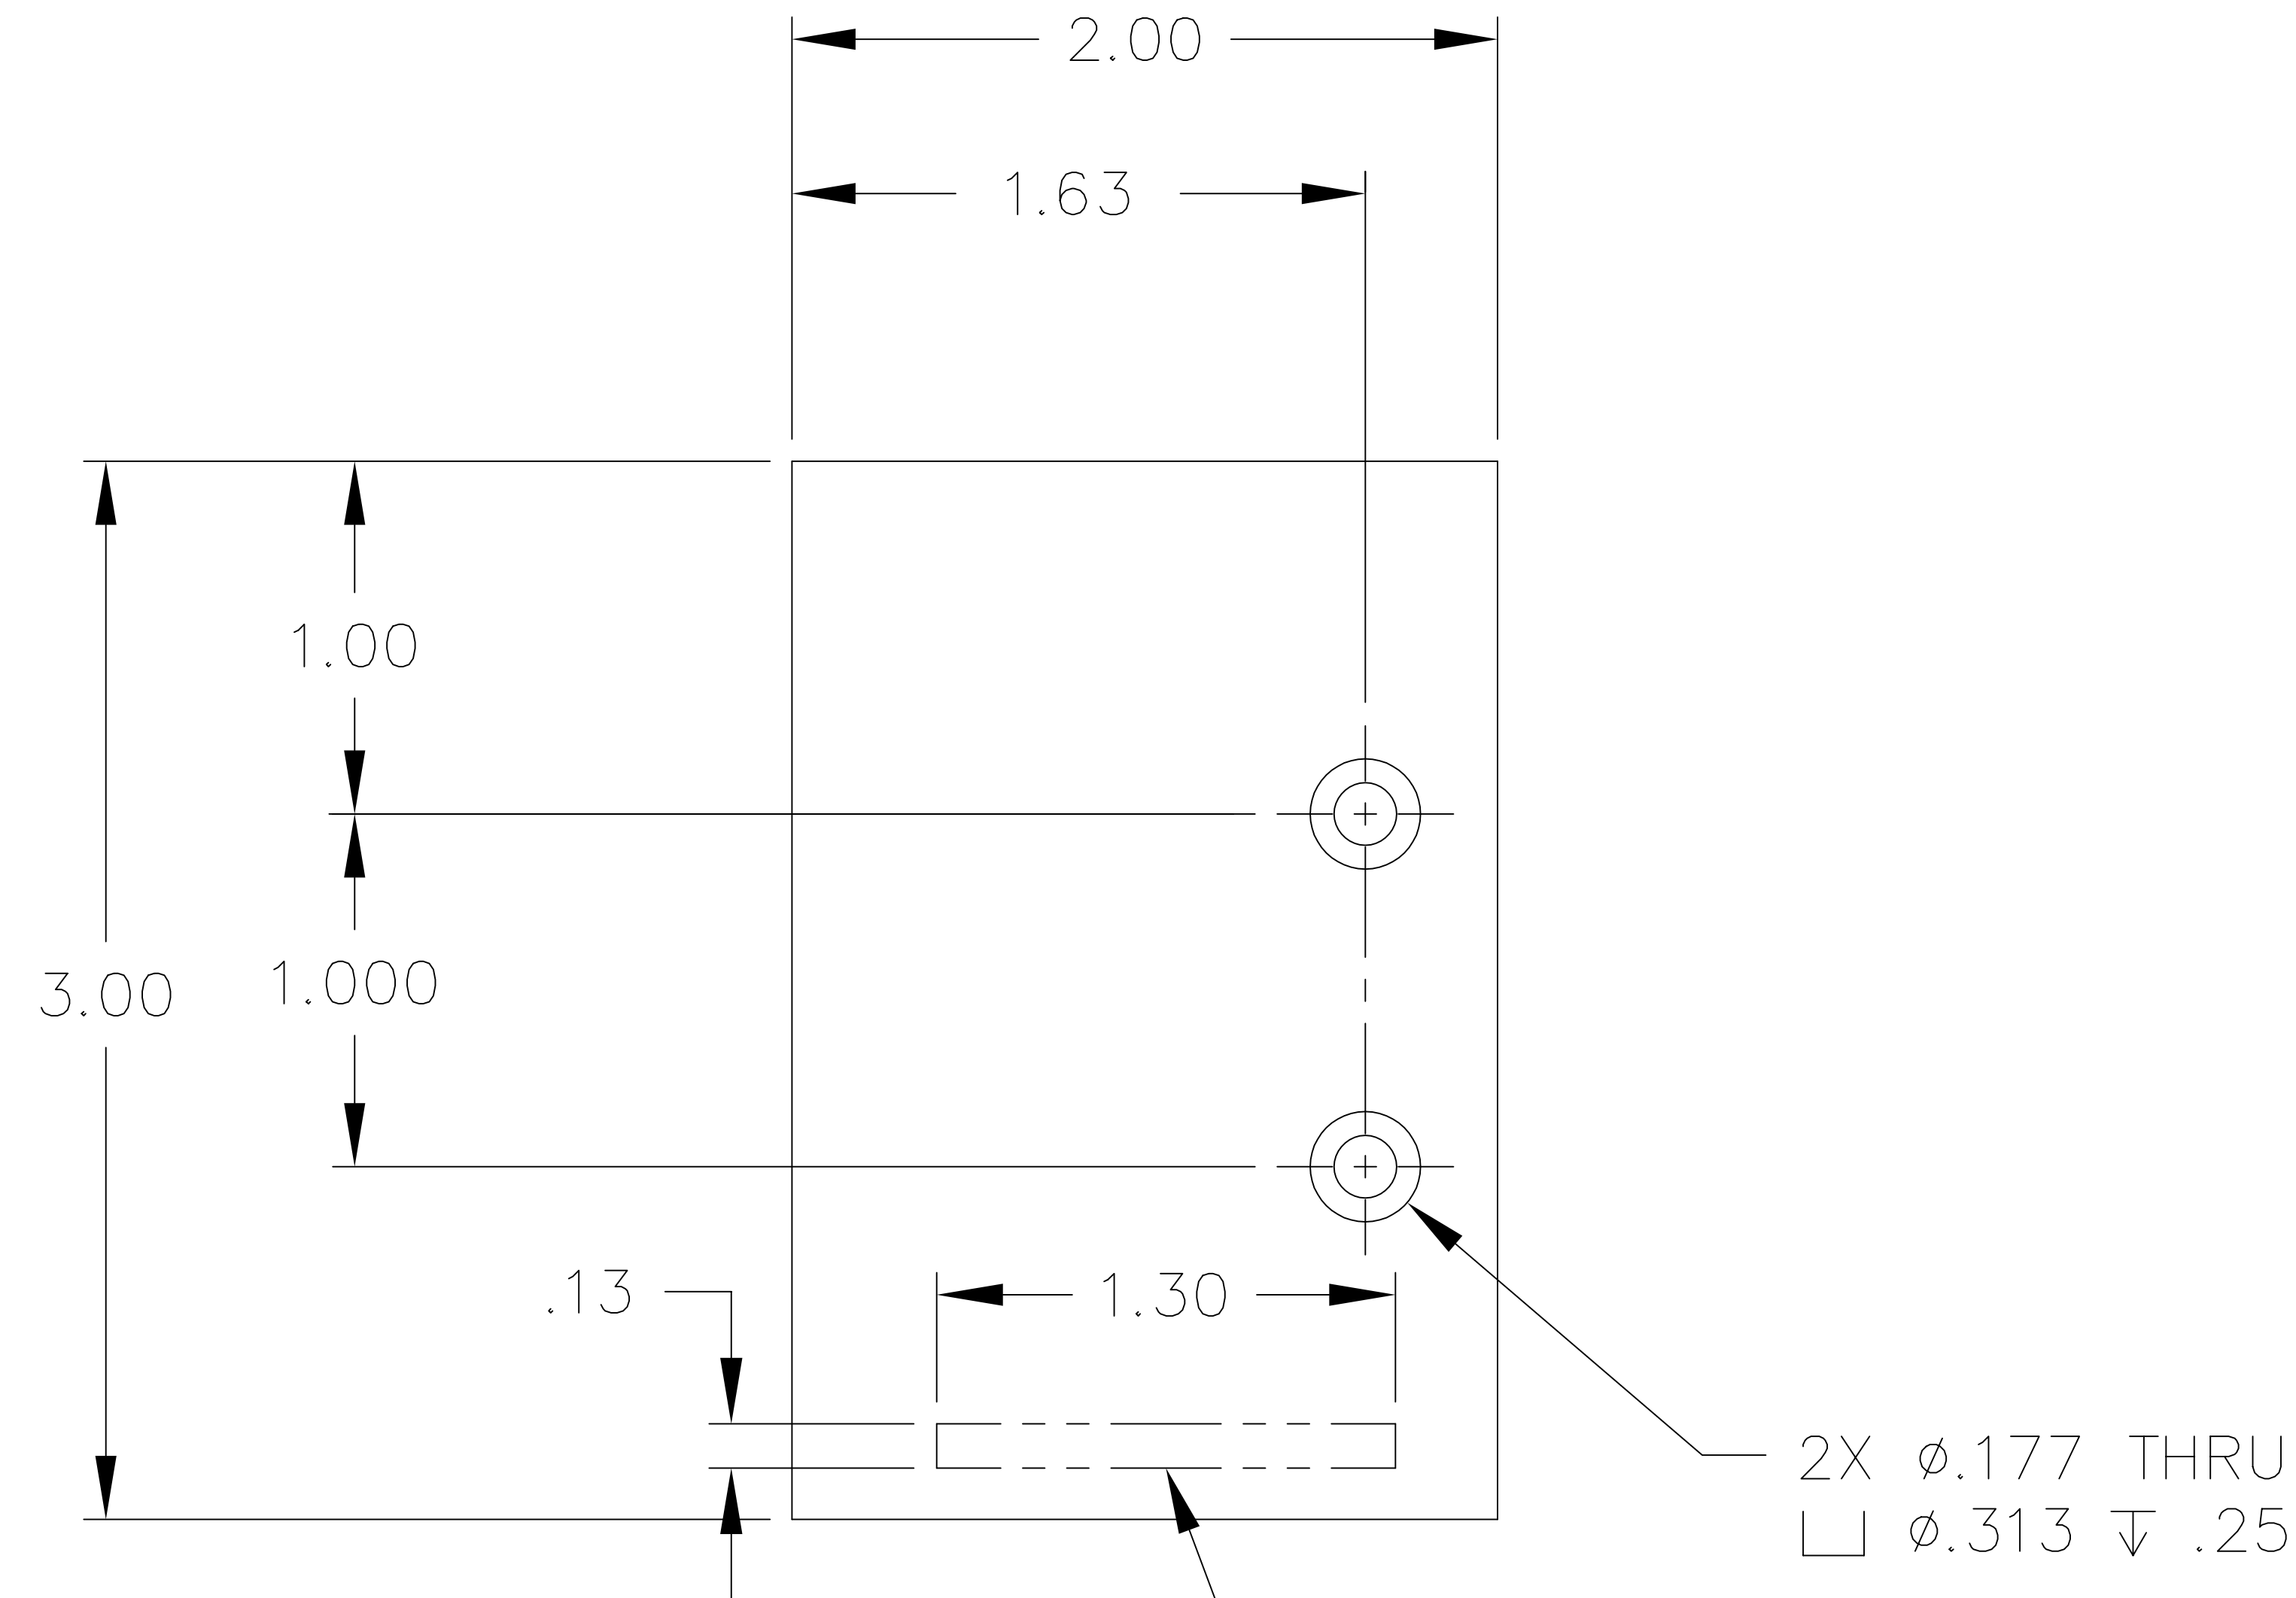
~~Liquid contaminants/Machining Lubricants~~
 Liquids containing hydrocarbons or other contaminants, other than the machining fluids specified herein, shall not be allowed to come into contact with suspension material at any time. All machining fluids shall be water soluble and free of sulfur, chlorine and silicone; such as Cincinnati Milacron's Cimtech 410 (stainless steel).

~~Identification Serial Number~~
 A serial number shall be etched, or scribed on the part see note drawing note.
~~Serial Number Format~~
 The Serial number shall be of the format: D99xxxx-x-001
